Subject: TAPPING NOISE WHERE EDGE OF DASHBOARD MEETS WINDSHIELD	Bulletin No: 09-004/13
	Last Issued: 03/06/2013

APPLICABLE MODEL(S)/VINS

2013 CX-5 vehicles with VINs JM3KE*****122583 ~ 146712 (produced May 6, 2012 ~ Aug. 31, 2012)

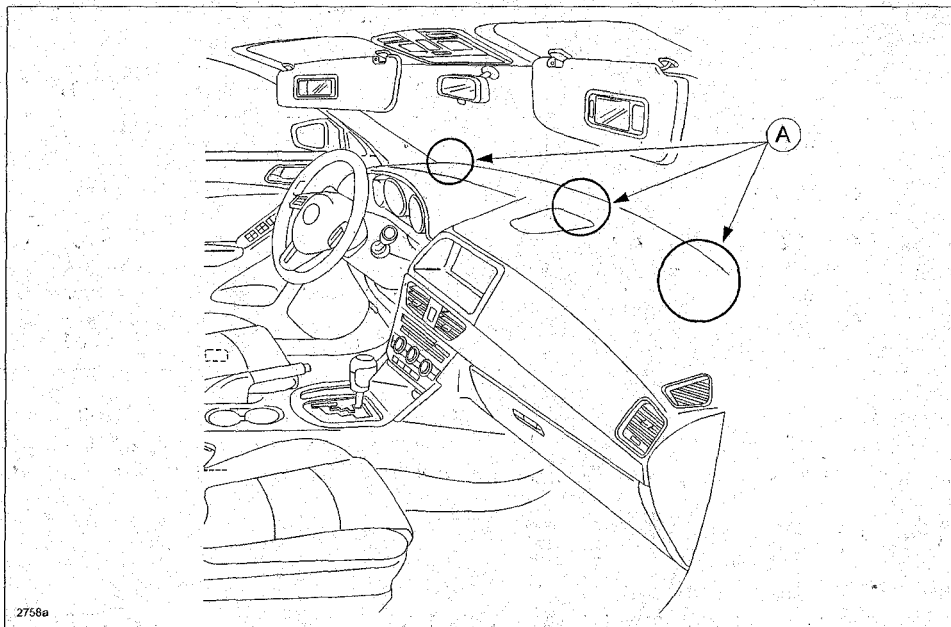
Some vehicles may exhibit a tapping noise which is audible from the front edge of the dashboard (A) (where it meets the base of the windshield) when driving over bumps or rough roads.

The tapping noise may be caused when the front edge of the dashboard contacts the body-side bracket(s). To eliminate the noise, felt pads have been attached to all (3) three body-side brackets during vehicle mass-production.

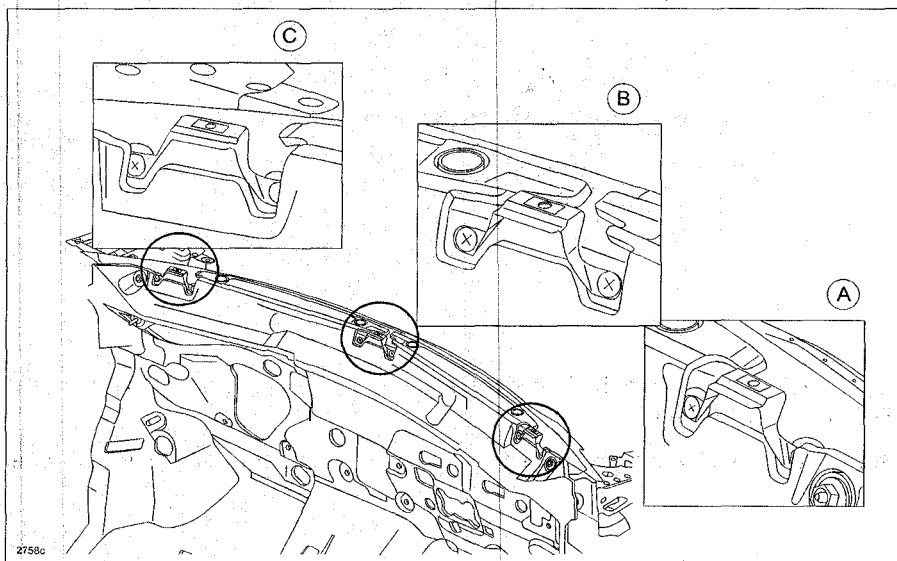
There are (3) three brackets (left, center and right) on the body-side as shown below (A). A felt pad is attached to each bracket for noise prevention. However, depending on the VIN and production date of the vehicle, felt pads may or may not have been attached to all three brackets. Vehicles without felt pads may experience a tapping noise when driving over bumps or rough roads.

Production date ranges for vehicles with and without felt pads: O = with felt pads, X = without felt pads.

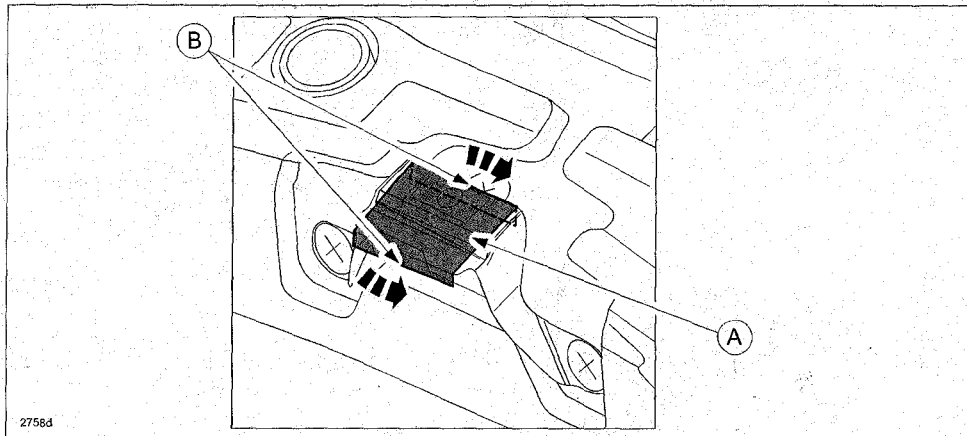
4. While lifting up the edge of the dashboard and holding it up by hand, attach the felt pads (A) on the brackets. Wrap the pad around the edges of the bracket as shown below (B).
 - For Type A Vehicles, attach a felt pad on all (3) three brackets (left, center and right).
 - For Type B Vehicles, attach a felt pad on the center bracket only.
